IDAHO DEPARTMENT OF WATER RESOURCES

RECOMMENDED WATER RIGHTS ACQUIRED UNDER STATE LAW

RIGHT NUMBER: 35-4246

NOTICE OF ERROR
REPLY

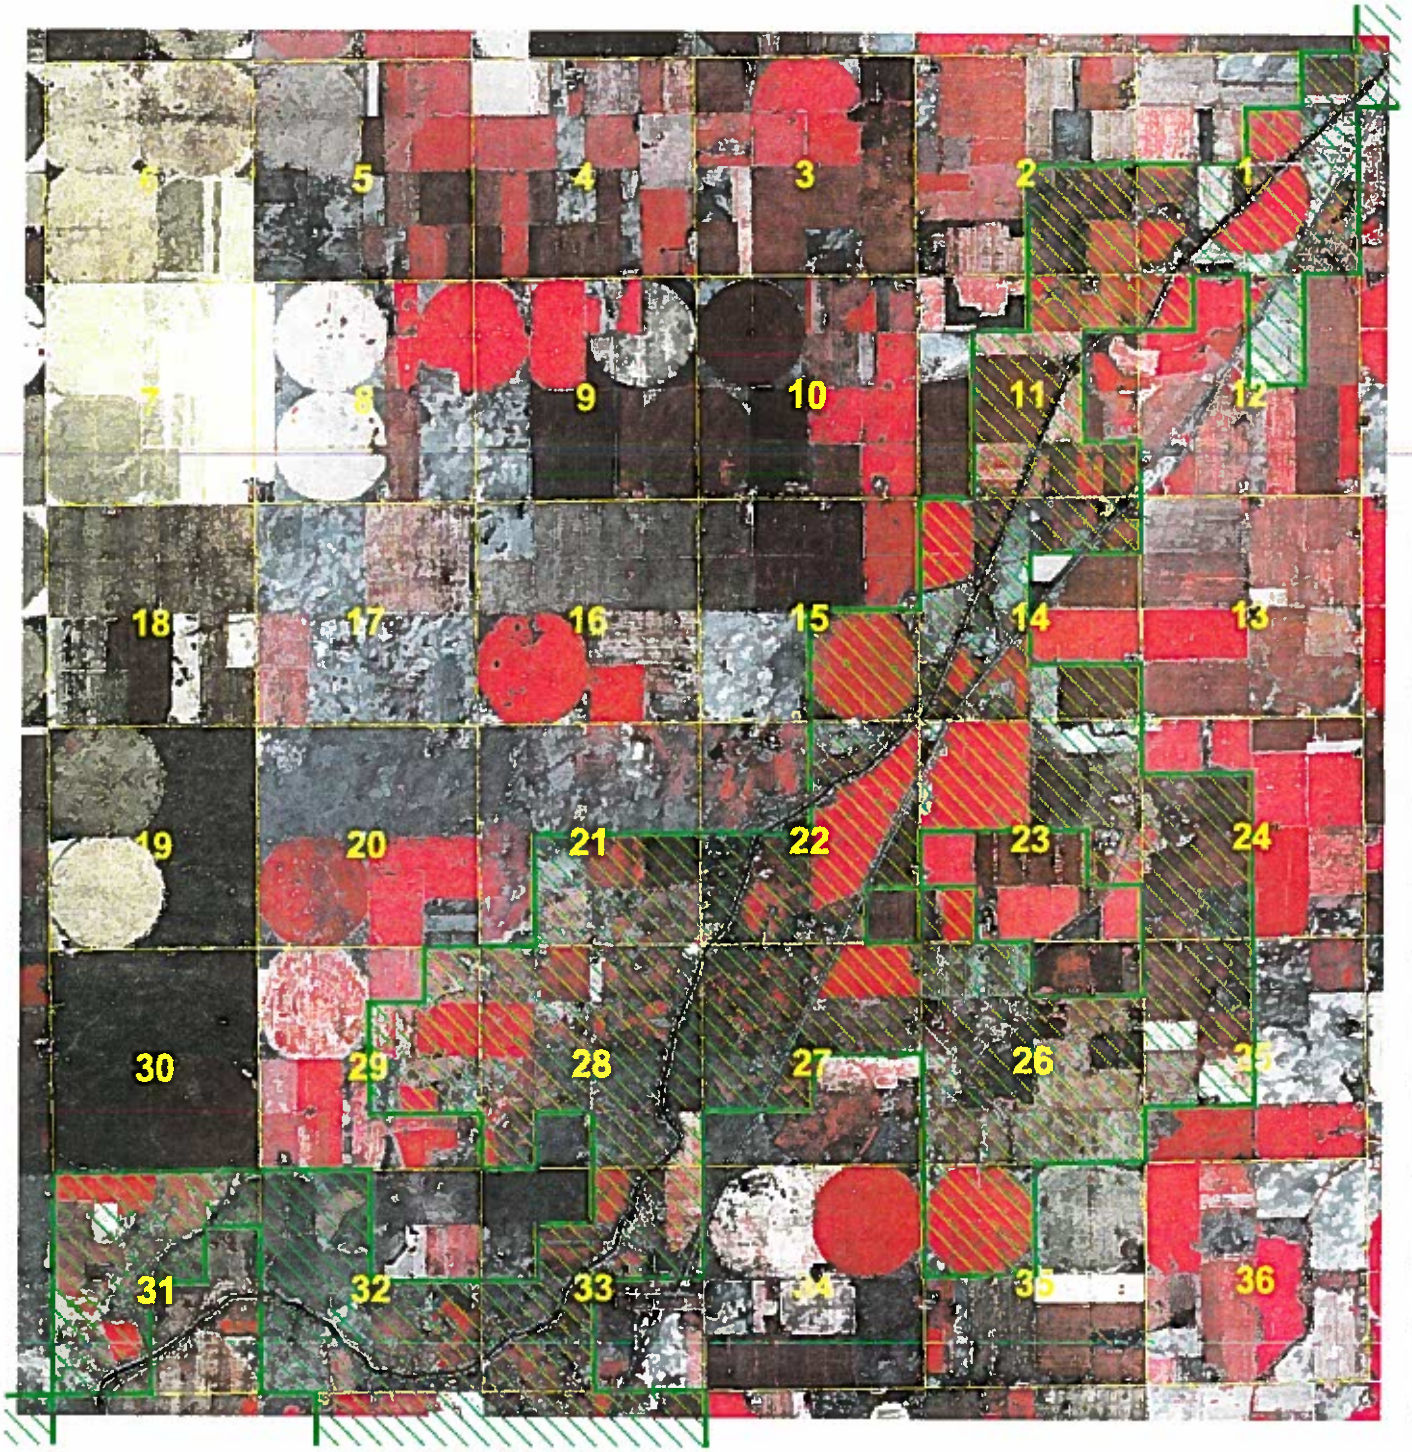
Sec 29 = reversed

28 ○ = need to check Grants like 13 - should be 18

T.3S. R.33E. Sec. 14 SENW

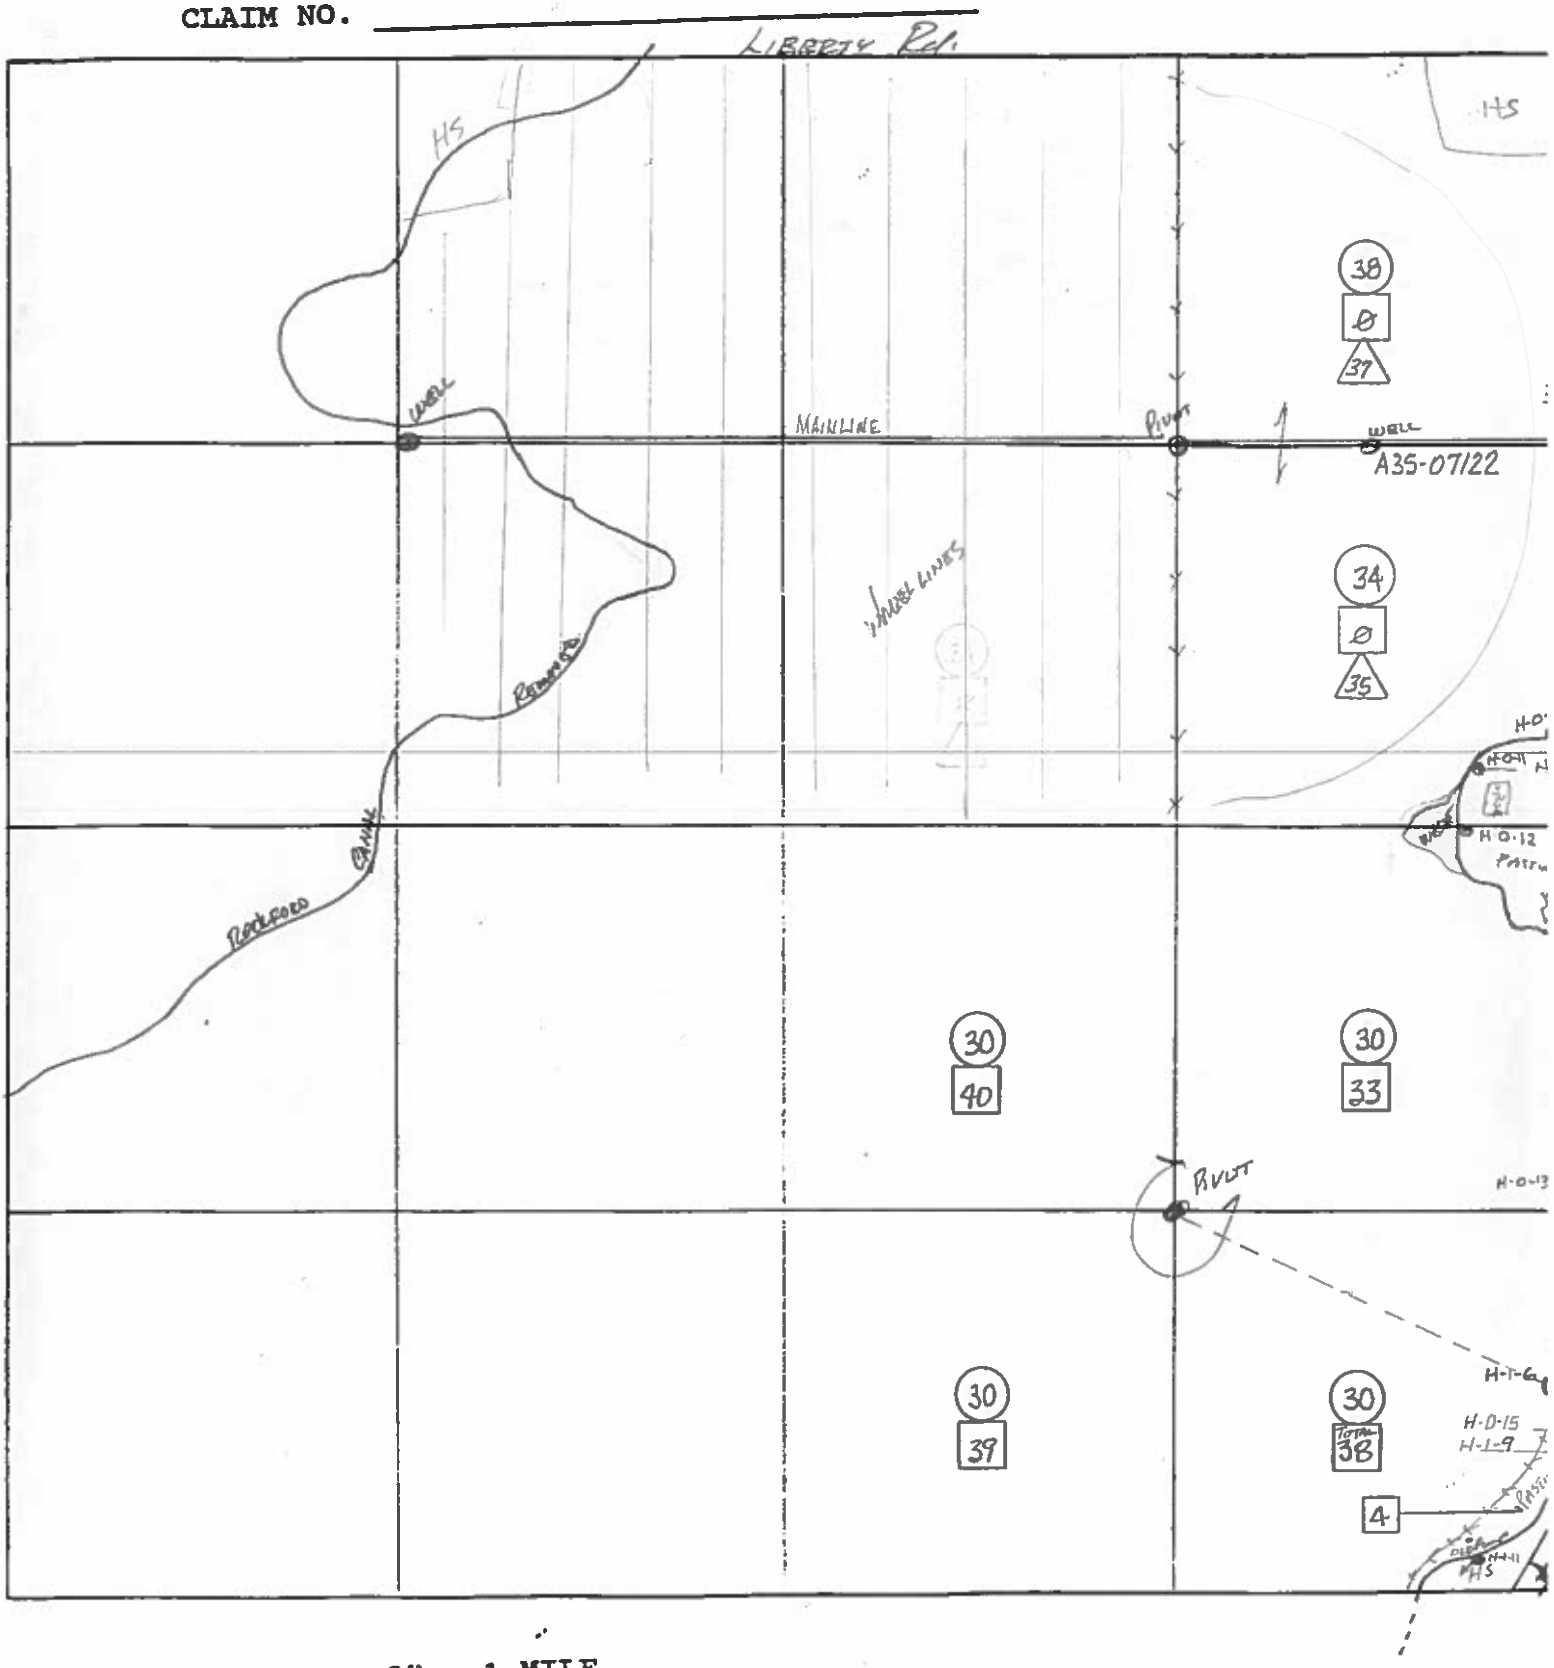
Diversions M-22-9 (Left) and M-22-10 Right

Both open 5/14/93 During field exam. - Field planted to hay

6/1/93 (Date of Photo) Shows both diversions closed - Field replanted to potatoes.

Anthony Galegos Property:
T.3S., R.3E., Sec. 24 SESW ASCS shows 33.8 ac

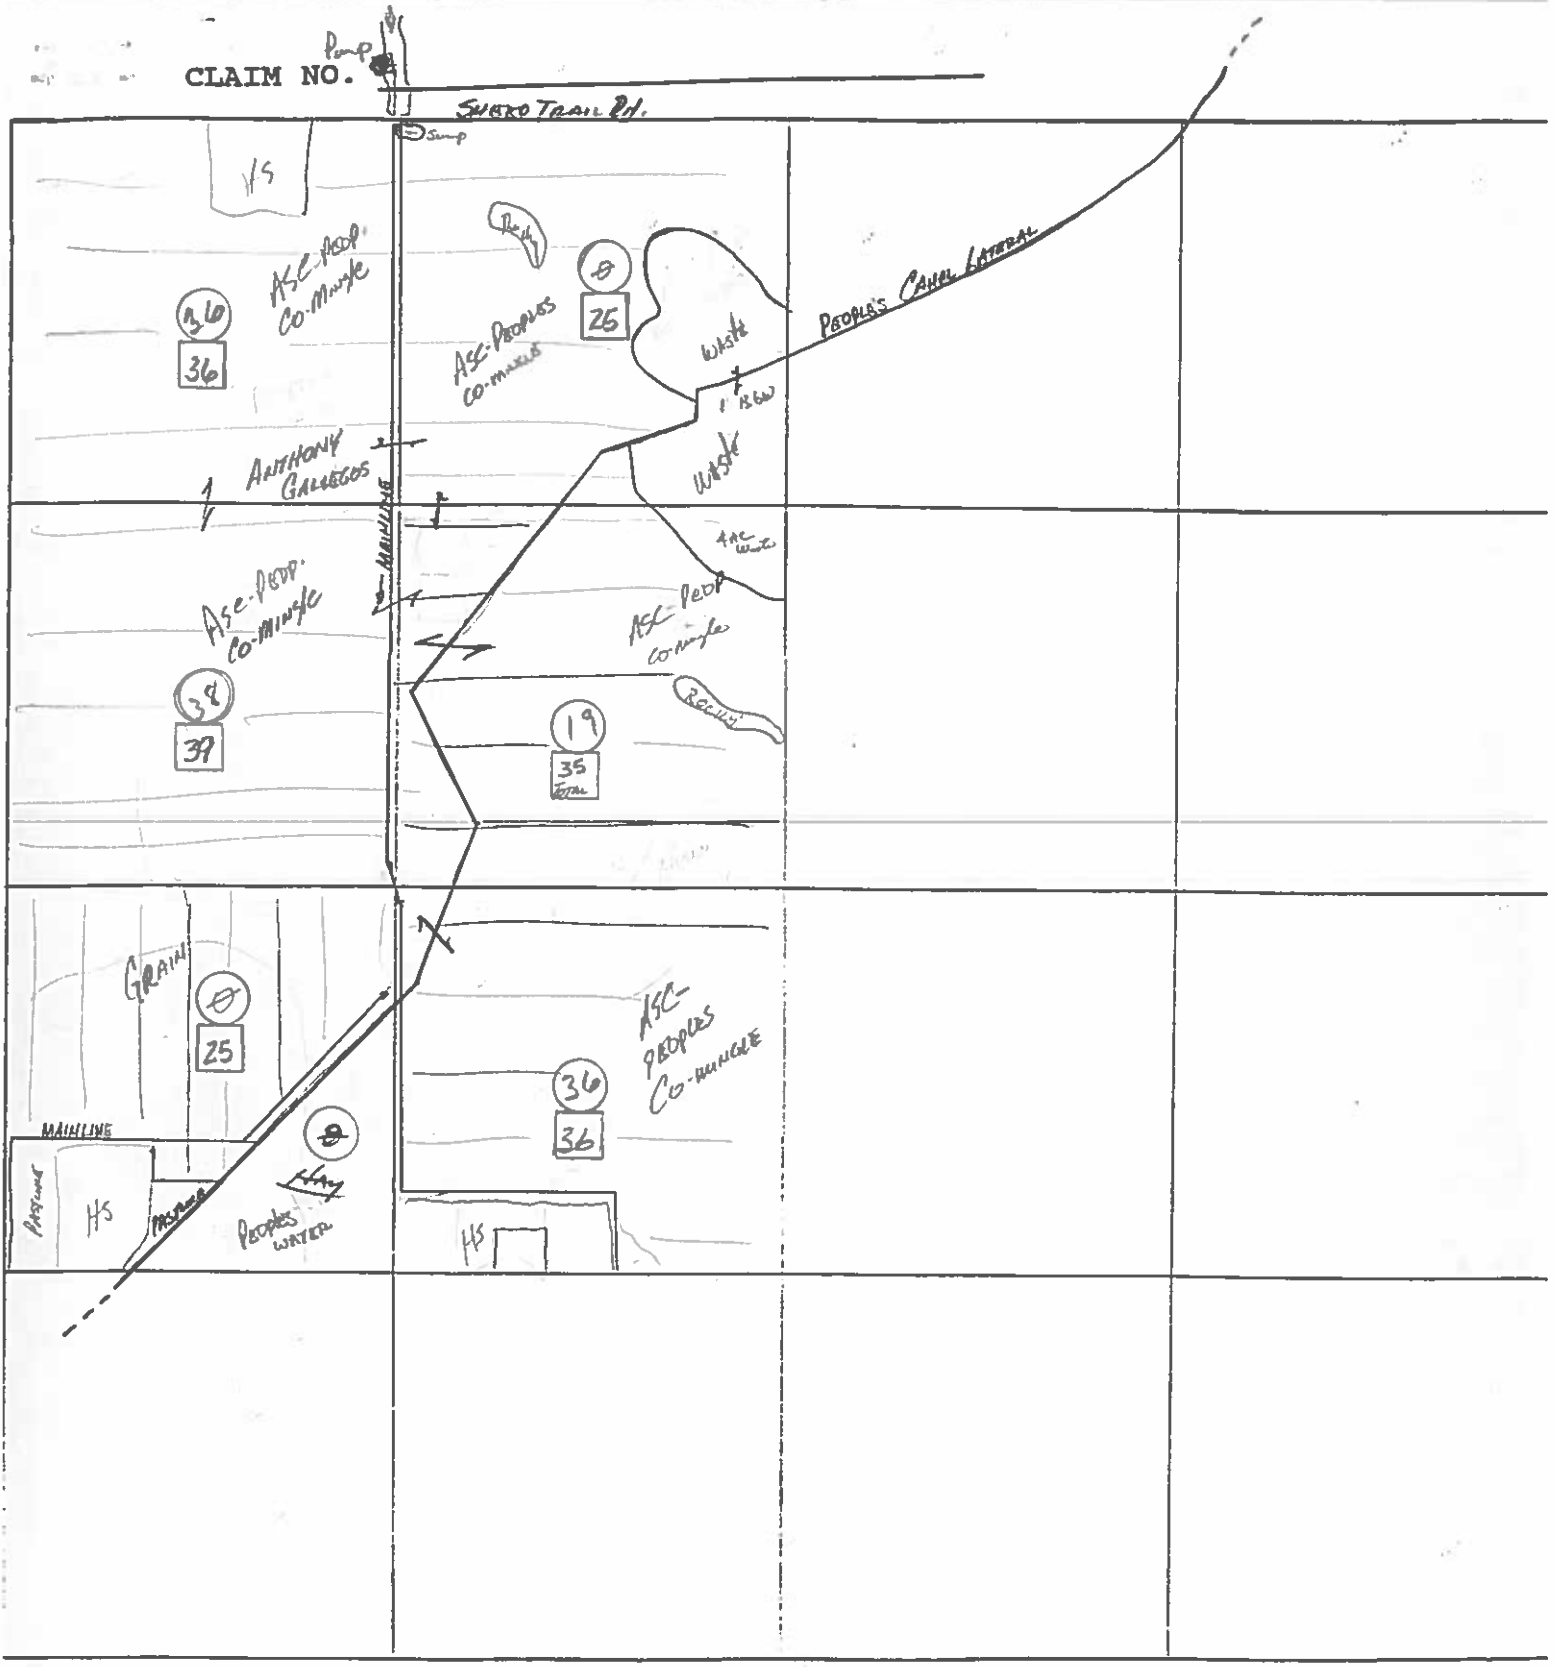
Looking North

T. 3S R. 33E SEC. 28 DATE 5/19/93 AGENT AMR

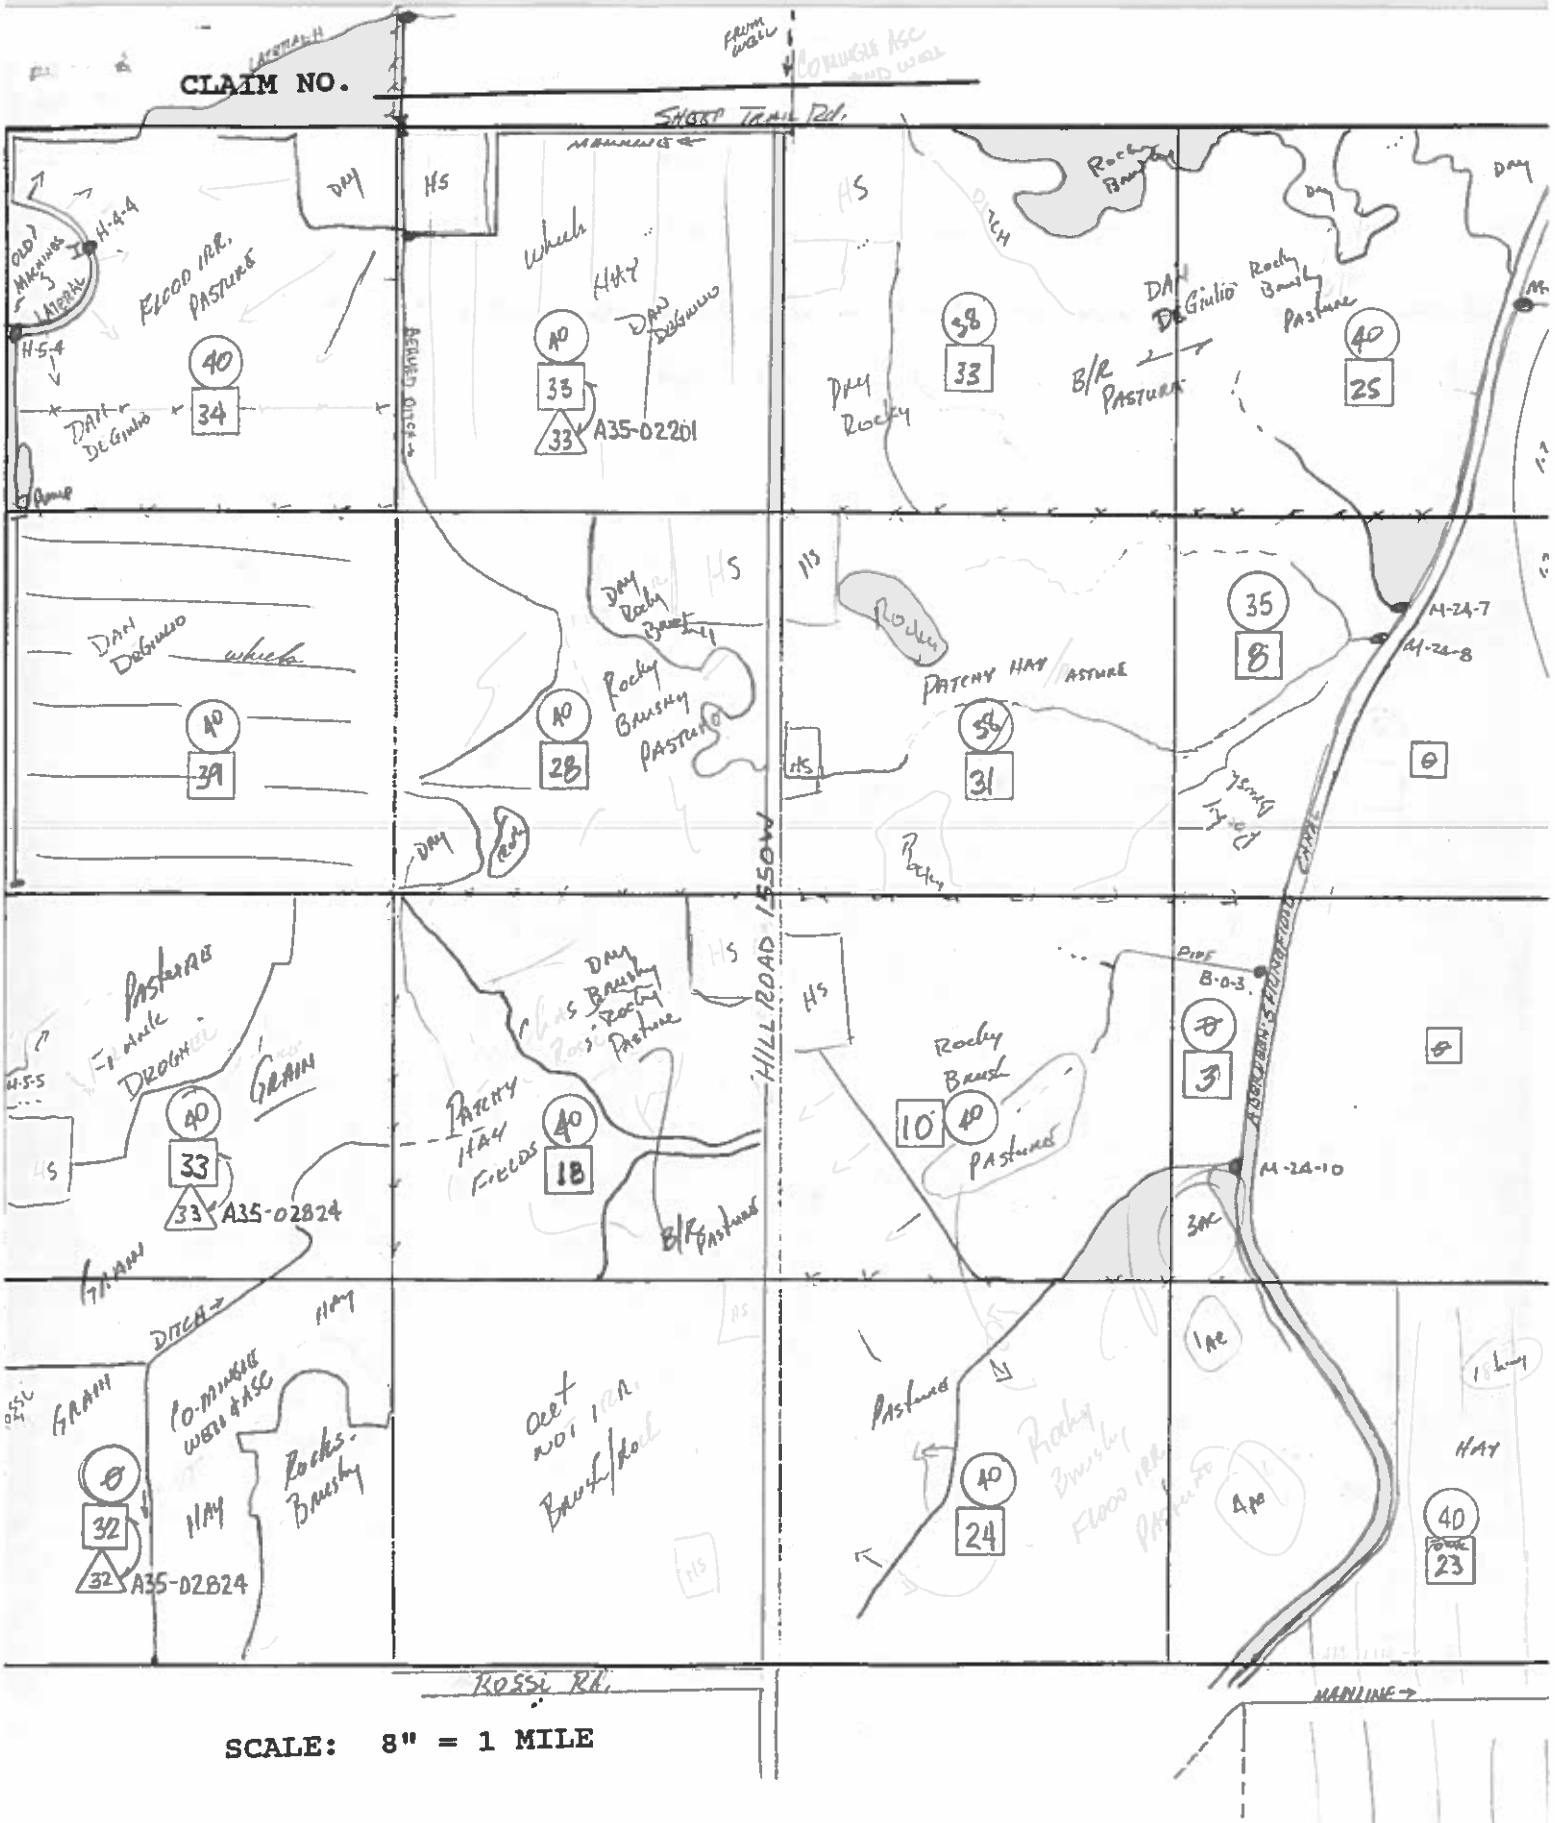
House is not part of Property
